Cover Page: Pre-Bid Minutes, Questions, Addenda

To:	All plan holders	From:	Tracy Bruun, Division
Pages:	15 including the cover sheet	Phone:	515-344-6279
Re:	Sio963414A Nutrient Reduction Wetland (Bid 25-05)	Date:	May 23, 2025

Subject: Addendum No. 1 to Bid Documents

Sio963414A Wetland Project - Bid No. 25-05

STANDARD DETAIL FOR SIGN INSTALLATION

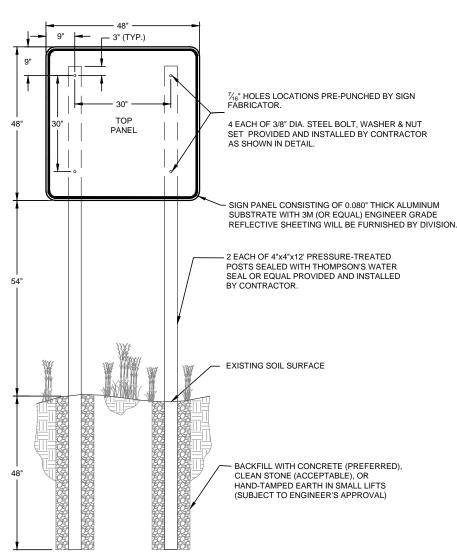
3. Subsidiary Item: Sign Installation
This item shall include all labor, materials, equipment, and Iowa One Call notifications to install a metal sign as provided by IDALS. Details are provided in Attachment #2.

- 1. DIVISION WILL FURNISH SIGN PANEL. CONTRACTOR IS RESPONSIBLE FOR PROVIDING POSTS, HARDWARE, AND INSTALLATION .
- 2. ALL EXPOSED WOOD SHALL BE SEALED WITH THOMPSON'S WATER SEAL OR EQUAL MEETING ASTM D-4446-08.

- 3. ALL STEEL HARDWARE PIECES SHALL BE GALVANIZED OR RUST RESISTANT.
- 4. NYLON AND STEEL WASHERS SHALL BE USED AS SHOWN ON THE BOLT, WASHER, NUT FASTENER DETAIL ABOVE.

- 5. CLEAR UTILITIES WITH IOWA ONE-CALL AT 811 OR (800) 292-8989 BEFORE EXCAVATING
- 6. SECURE DIVISION AND LANDOWNERS APPROVAL FOR SIGN LOCATION BEFORE INSTALLATION.

- 7. COSTS FOR POSTS, HARDWARE, WOOD SEALANT AND SIGN INSTALLATION SHALL BE INCIDENTAL TO MOBILIZATION.
- 8. CONTRACTOR SHALL INSTALL SIGN POSTS USING A PLYWOOD OR OTHER SUITABLE TEMPLATE TO MAINTAIN ACCURATE POST SPACING AND ALIGNMENT DURING BACKFILLING OF THE POST HOLES. TO AVOID BENDING OF THE SIGN PANELS, POSTS SHALL NOT BE INSTALLED OR BACKFILLED WITH SIGN PANELS ATTACHED.

- 9. ONE (1) PROJECT SIGN SHALL BE INSTALLED UNLESS NOTED OTHERWISE.
